**BEFORE
THE OHIO POWER SITING BOARD**

In the Matter of the Application of	)	
Kingwood Solar I LLC for a Certificate	)	Case No. 21-0117-EL-BGN
of Environmental Compatibility and	)	
Public Need	)

**KINGWOOD SOLAR'S JUNE 1, 2021 RESPONSES
TO STAFF'S MAY 17 AND MAY 20 DATA REQUESTS**

Figure DR1-13
Layout Constraint Considerations

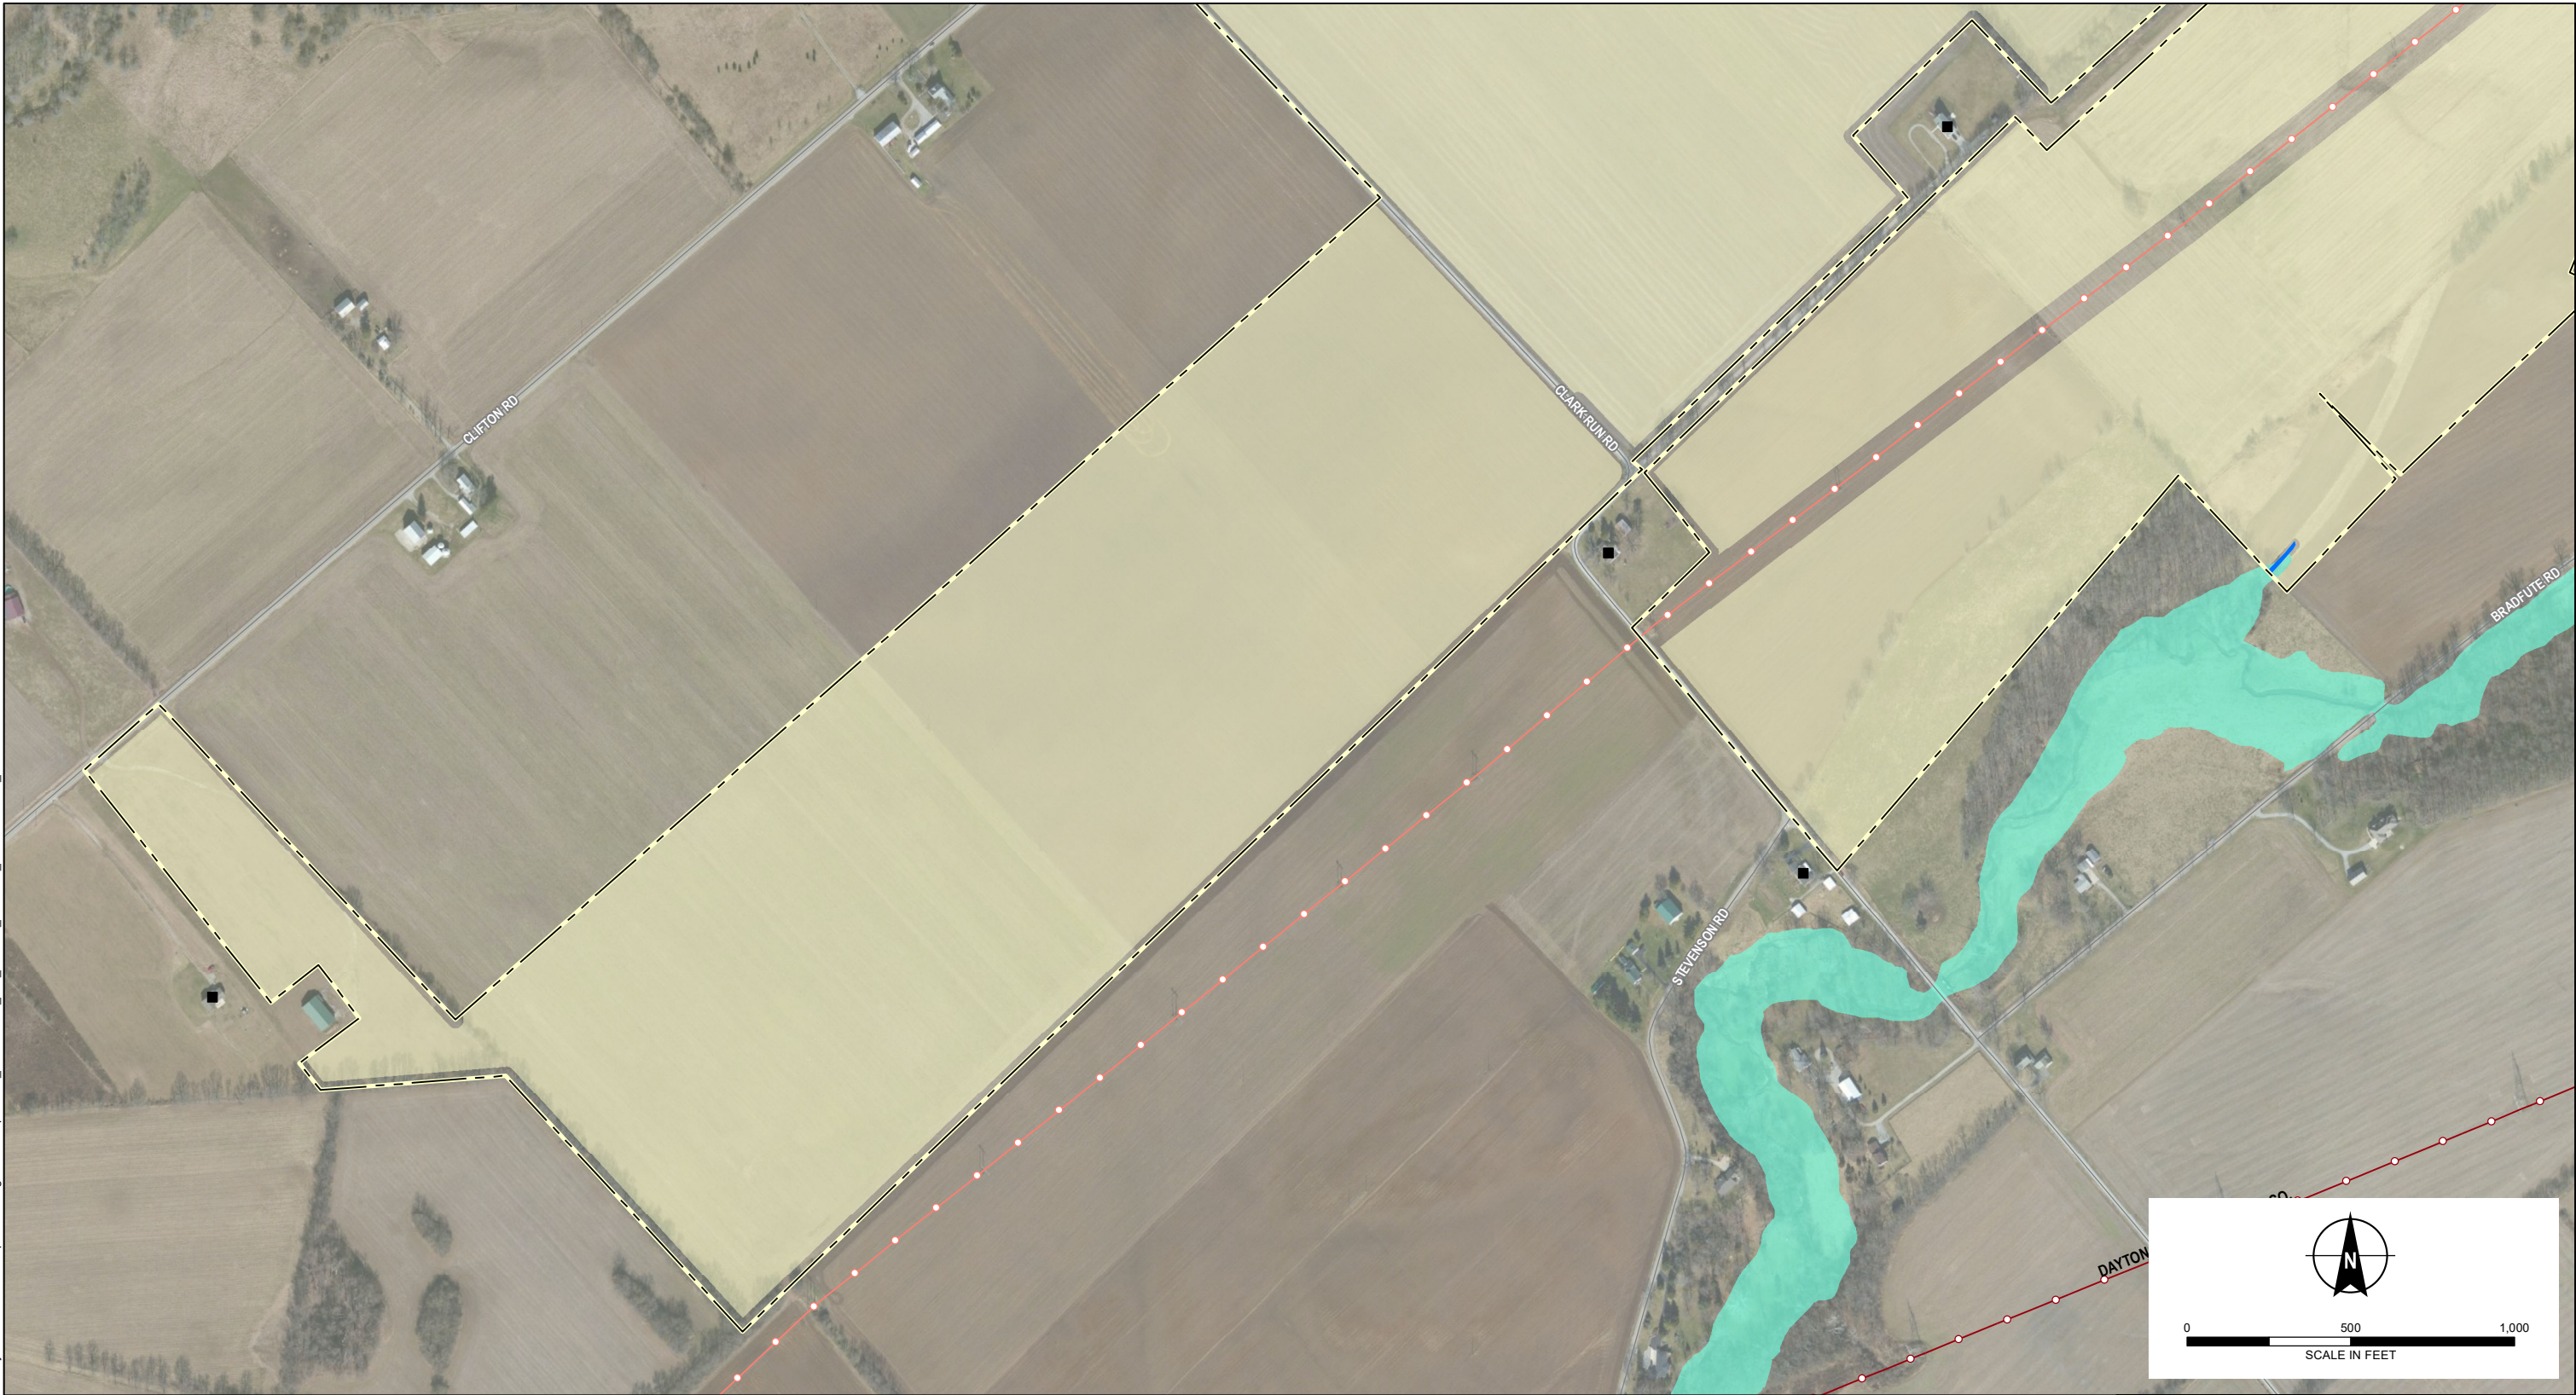
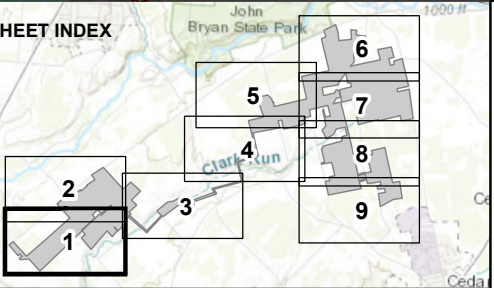
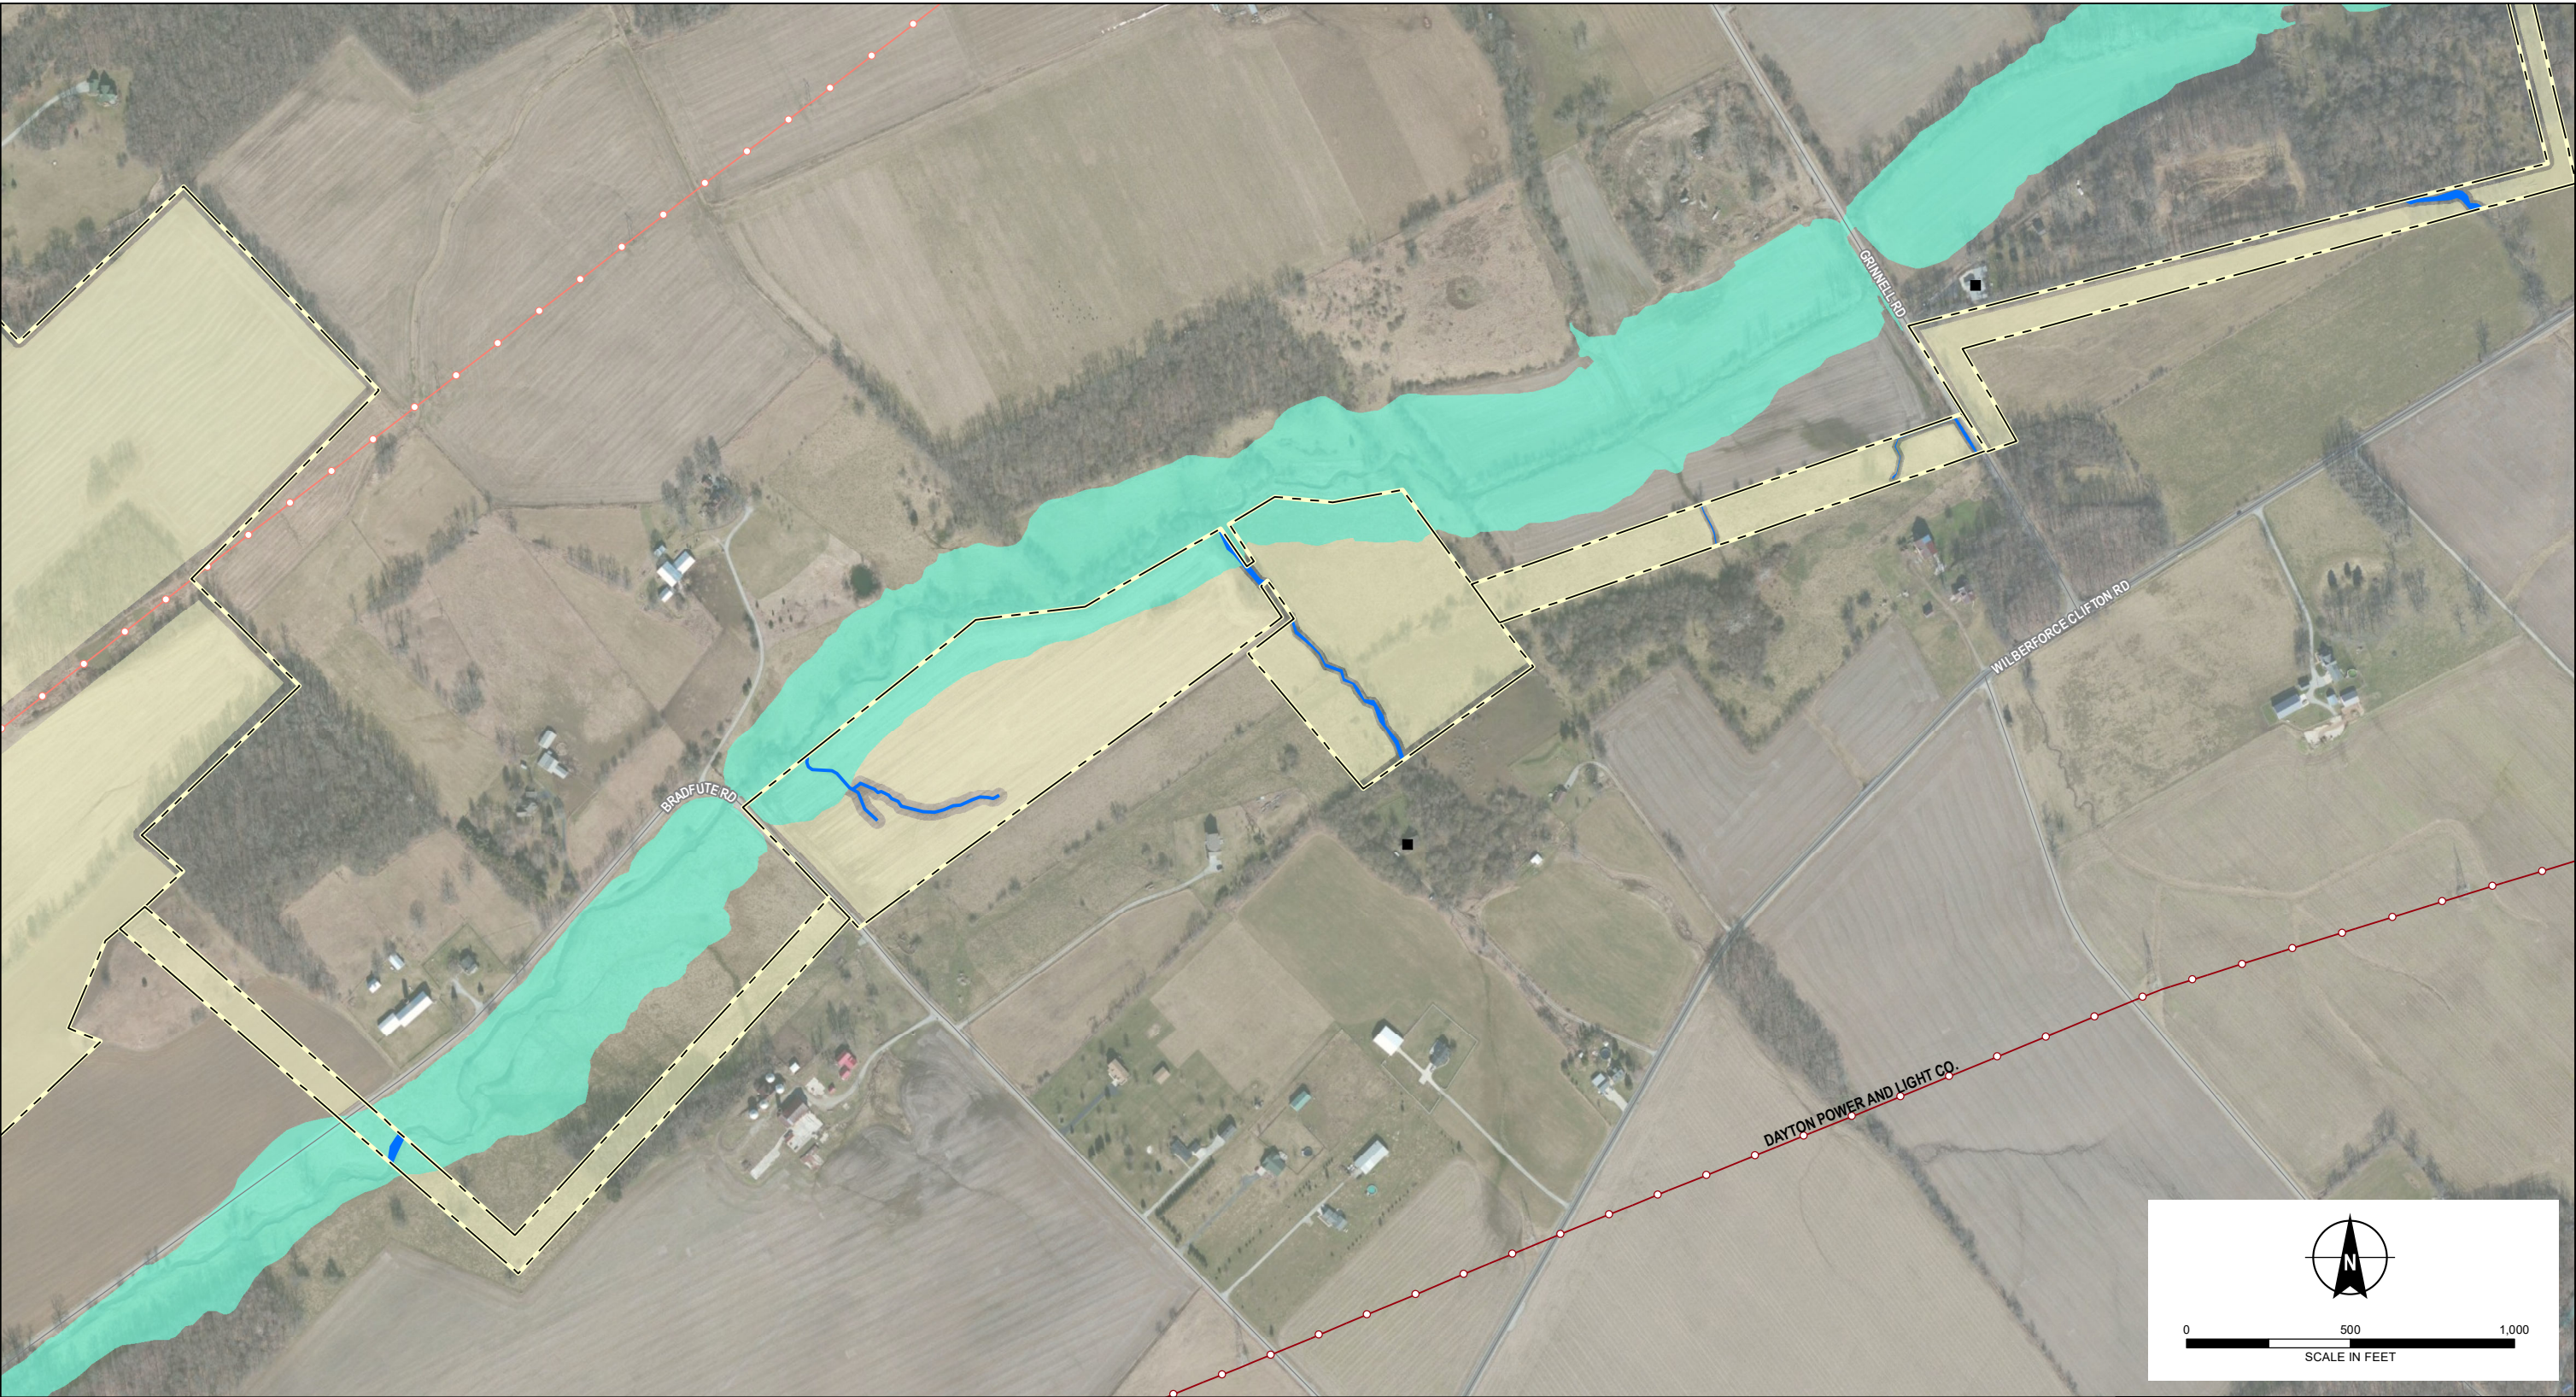
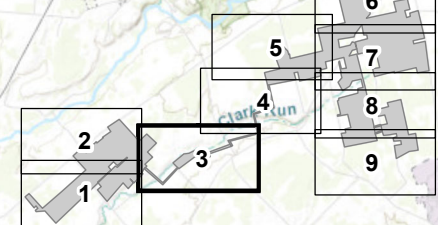
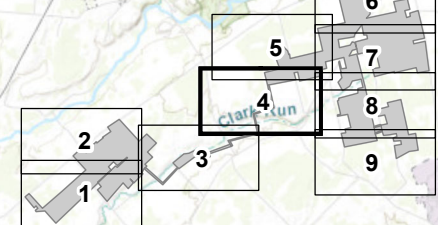
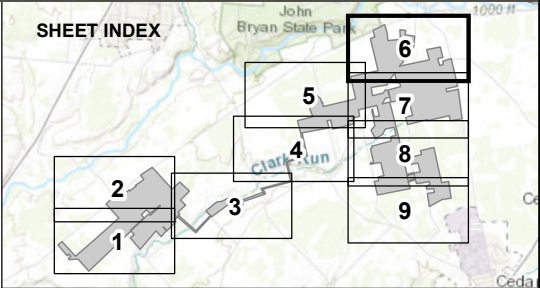
13. Figure 04-2 does not show setbacks from residences, property lines, utility corridors, and public rights-of-way, and any other constraints of the site design. Please provide a map that provides a constraint map showing setbacks from residences, property lines, utility corridors, and public rights-of-way, and any other constraints of the site design.

Figure DR1-13 illustrates the constraints considered for the Project layout. This map is intended to show the maximum extent of potential solar array areas while avoiding existing public rights-of-way and existing easements (utility corridors), with a minimum setback from abutting property lines of 25 feet.

138kV STEEL POLE TYPE - 75'

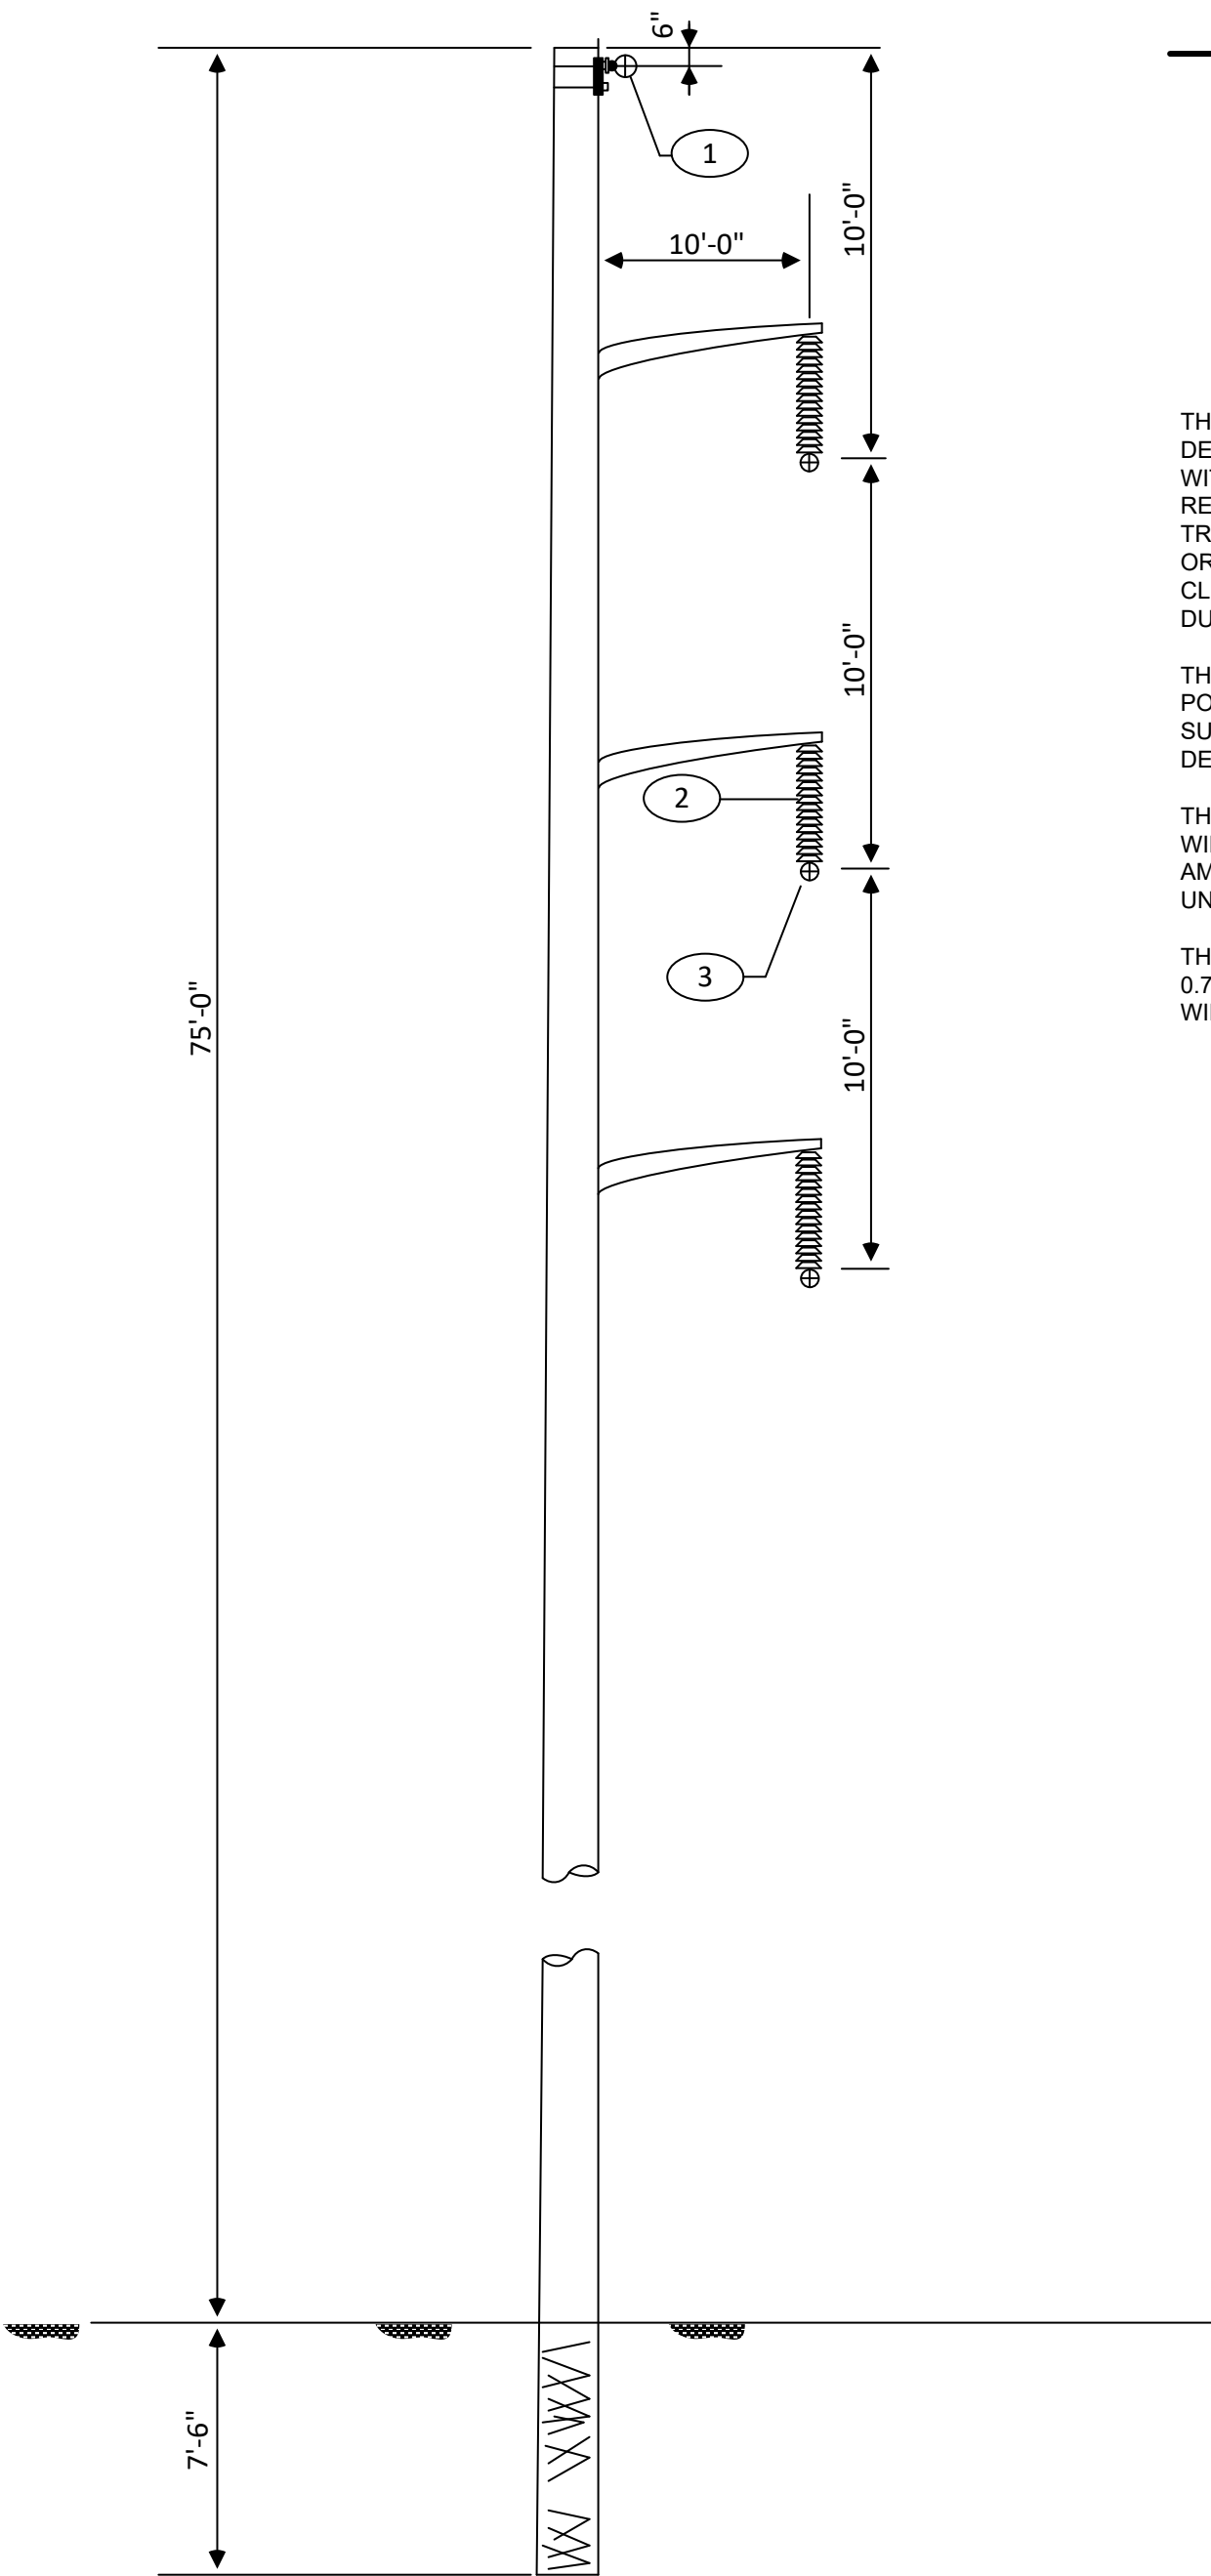
- 16. Tower designs, pole structures, conductor size and number per phase, and insulator arrangement.***
- 17. Base and foundation design.***
- 18. Cable type and size, where underground.***
- 19. Other major equipment or special structures.***

Kingwood Solar has not yet received its final Facilities Study Report from PJM, which in conjunction with the Construction Services Agreement will specify the required gen-tie facilities

in greater detail. The specific design process is expected to take place between January-April 2022. Please see Exhibit DR1-15 for a typical 138kV gen-tie pole structure.
